GARAGE ADDITION PROPOSAL
2903 W MCKINLEY

HPC meeting date: 11/4/2019
Ald. Robert Bauman District: 4
Staff reviewer: Tim Askin
PTS #114852 CCF #191001
Property

Milwaukee Historic Preservation Commission Staff Report

2903 W. MC KINLEY BL.

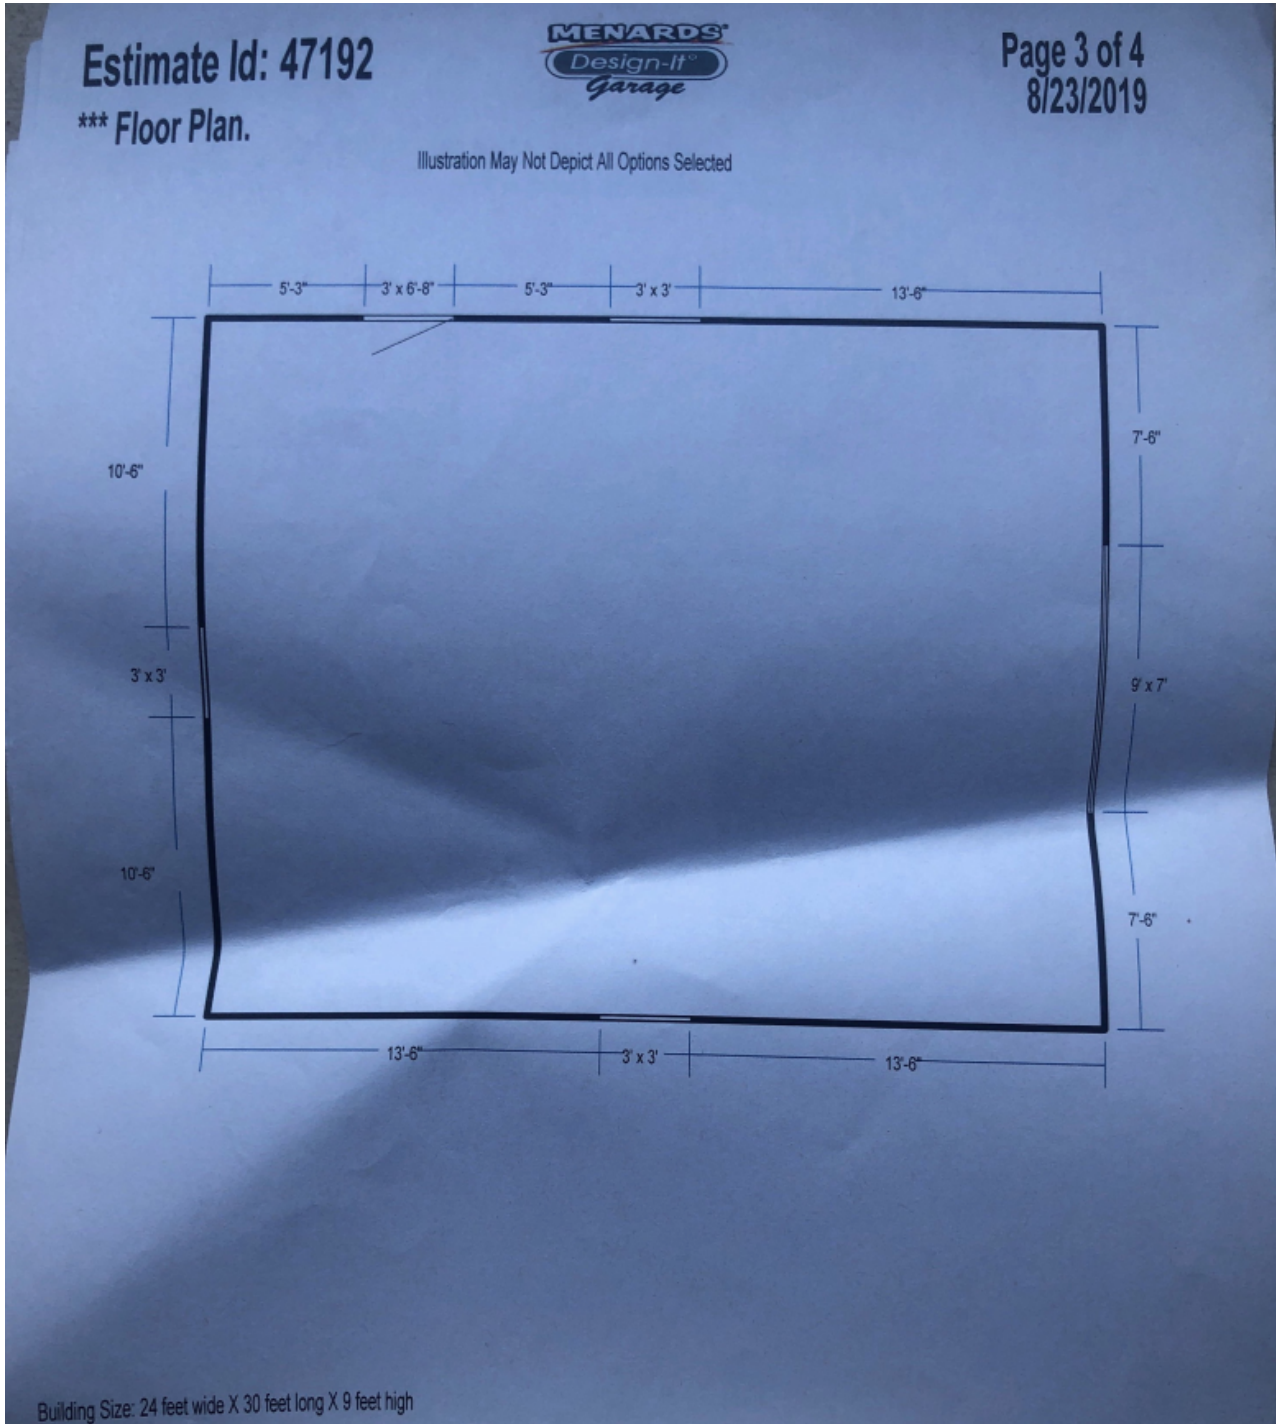
This application is for a garage addition. The plans provided indicate a front gable design with minimal designed articulation. The estimates provided indicate that the garage will be clad in 4" vinyl siding, feature vinyl soffit and fascia, three vinyl window units, a single steel service door, and a steel overhead door. The elevations included with the application package indicate interest in a craftsman style garage. A collaged image indicates a garage in this style as well, but the applicant specified in their description that the image "does not reflect an exact color scheme or design."

Materials proposed vinyl siding and vinyl windows. These materials have not been accepted by the Commission for any new construction because of their inherent dissimilarity to historic materials. Vinyl siding will also complicate fire separation between the buildings. Very few vinyl siding products are approved for used in 2 hour fire-rated assemblies. It is not known what can be used in a 3/4 hour assembly (<http://productspec.ul.com/document.php?id=BXUV.U301>). Windows of any material will not be feasible on any side of a proposed garage within 10' of another structure because of fire rating requirements (SPS 321.08).

HOLD for referral to Plan Examination and Board of Zoning Appeals for siting and fire-rating issues.

Or DENY based on materials.
